**47 Johnston Road, Mossman Gorge, MCU (Retirement Facility)  
Information request response (pursuant to Section 13 of the Development Assessment Rules)  
Your Ref: MCUC 2023\_5532/1**

### **Information Request Response - 47 Johnston Road, Mossman .**

TURN PATH ASSESSMENT  
B99 MANOUVRES

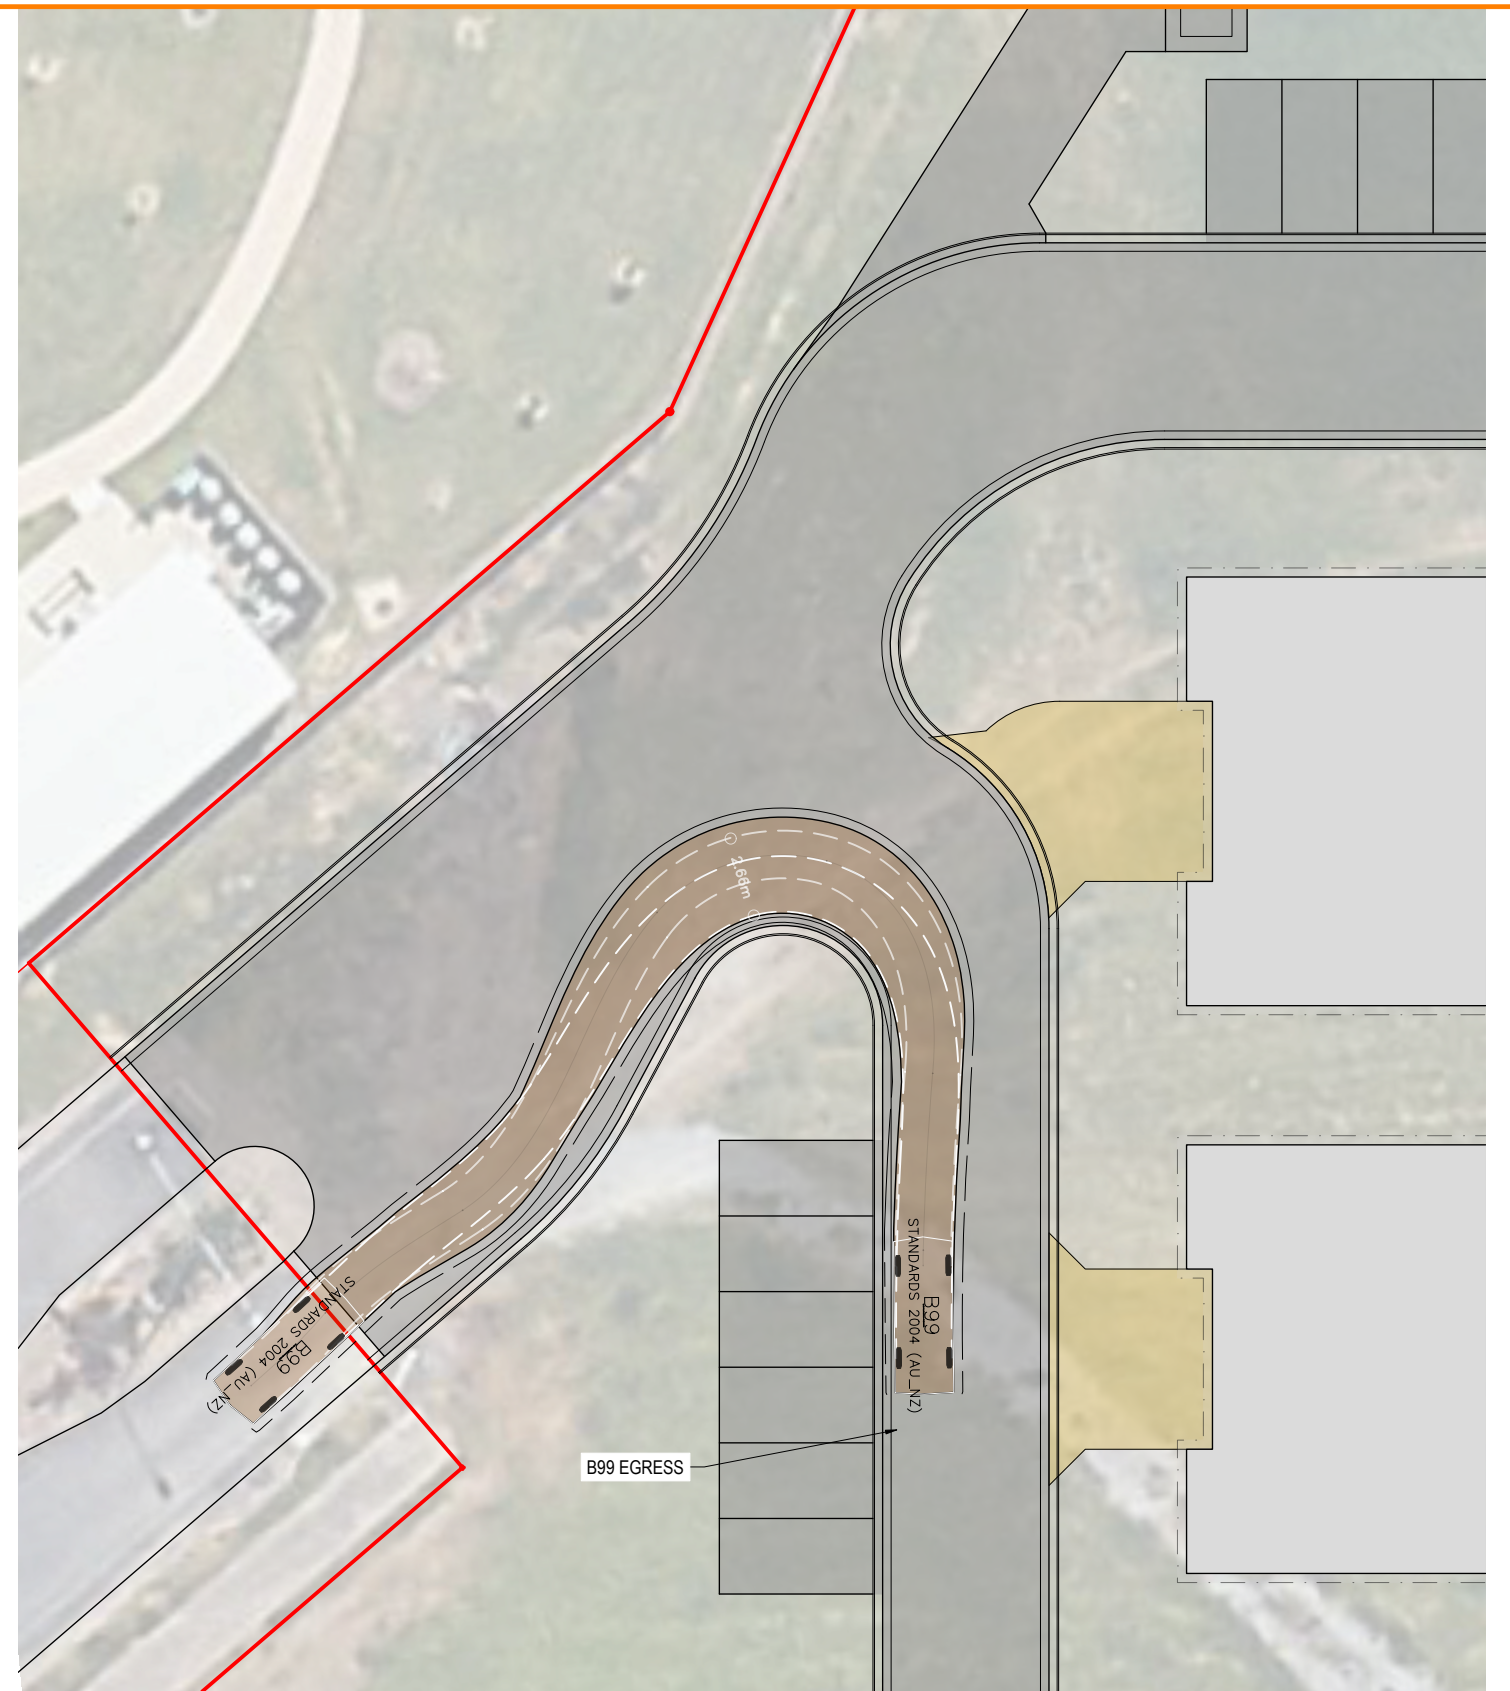
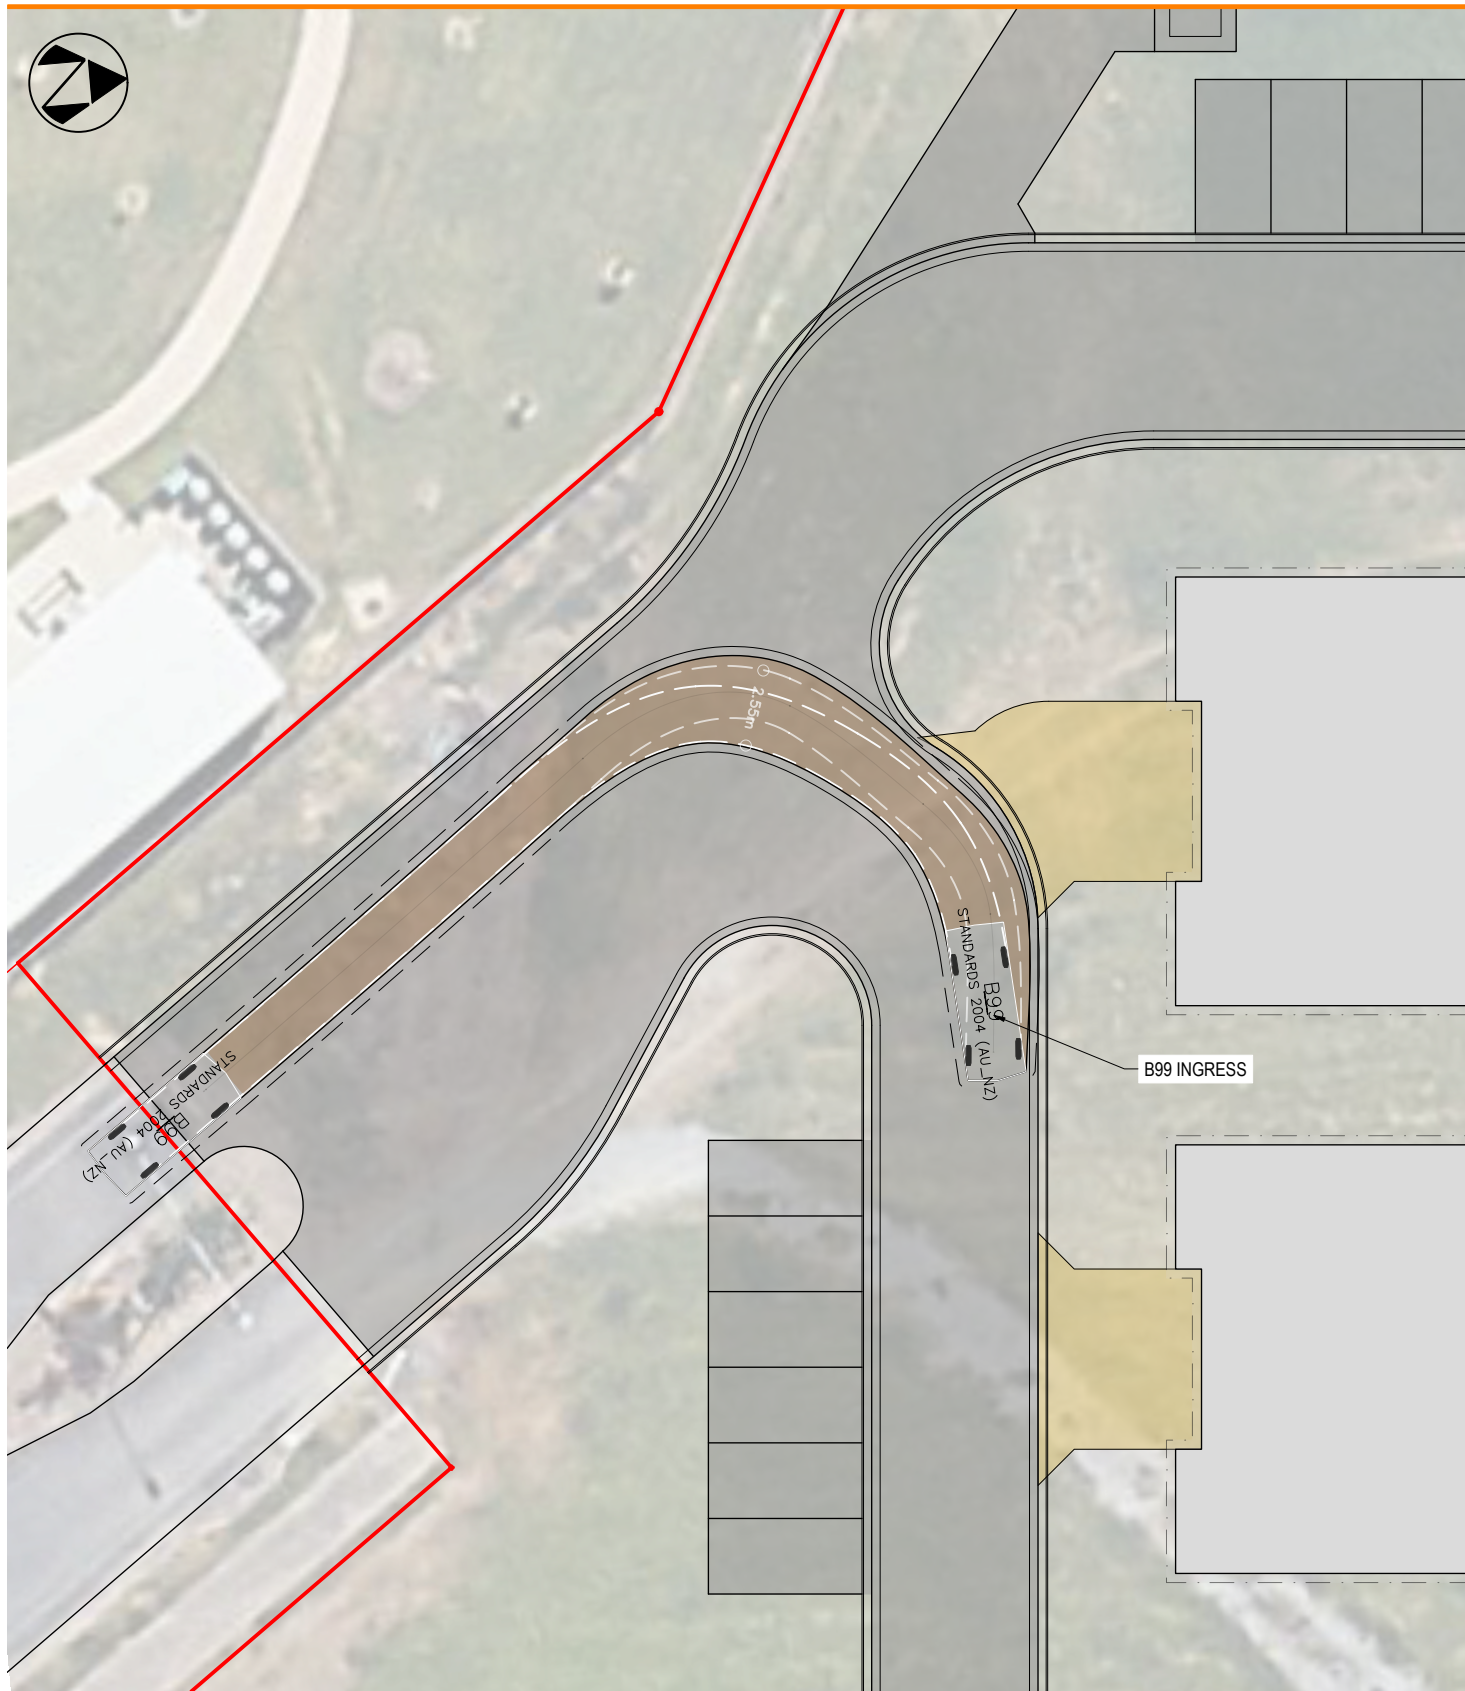
Amend the plans to enable a B99 design vehicle can turn-around at the end of all proposed road stubs without relying on driveways servicing the dwelling units. Vehicles performing a 3 point turn would be acceptable.

7. *Amend the plans to enable a B99 design vehicle can turn-around at the end of all proposed road stubs without relying on driveways servicing the dwelling units. Vehicles performing a 3 point turn would be acceptable.*

Additional pavement has been provided to the inside bends of the road in the attached plans. Turn paths of design vehicles are also included.

CATCHMENT PLAN - EXISTING CASE

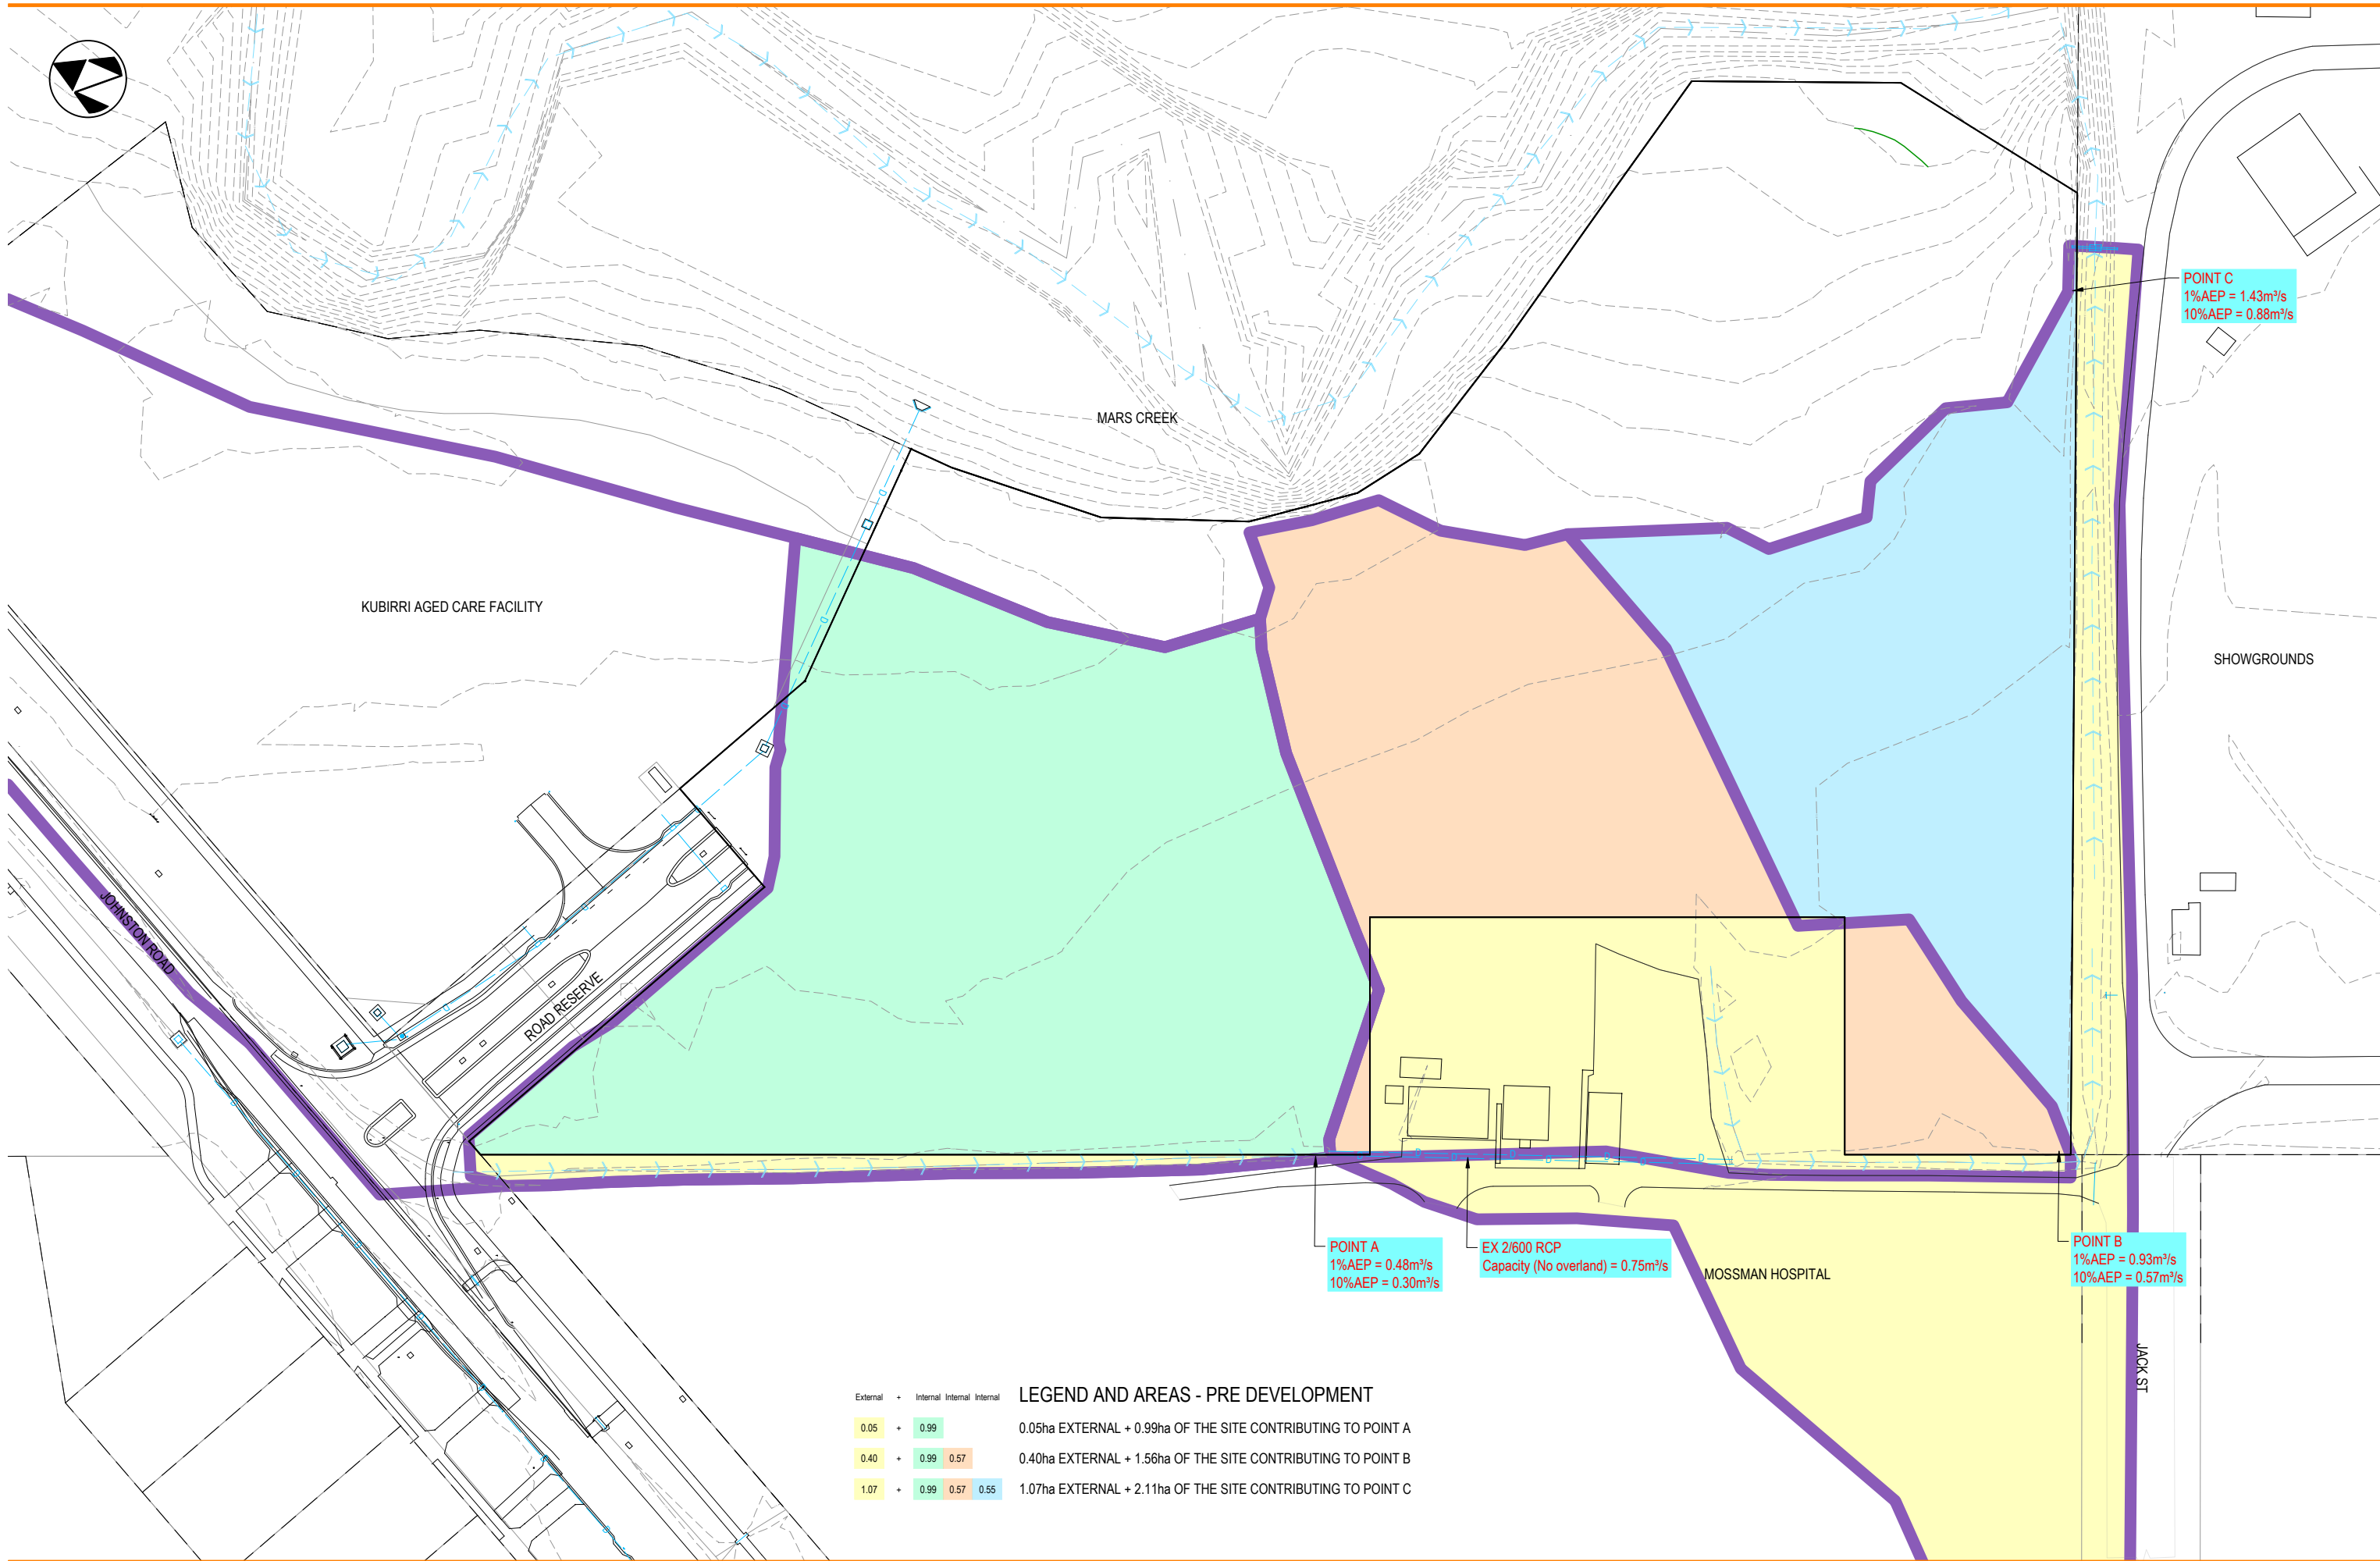
9. *The Applicant is requested to provide updated local drainage catchment plan(s) and calculations of the site, noting the apparent catchment changes discharging North to the Showgrounds drains. The additional information must consider the drainage impacts on downstream properties and the potential capacity upgrades to address the changed flows. In particular, the plan(s) and drainage advice must address the following:*

- a. *All internal and external contributing catchment boundaries pre- and post- development focusing on the catchment to the underground pipes in the hospital grounds (eastern boundary of development site) and the additional catchment captured by the bund and directed to the showgrounds drain;*

Additional catchment plans have been attached.

The existing 2/600mm diameter RCP has capacity for 0.75m<sup>3</sup>/s, and has been noted on the catchment plans.
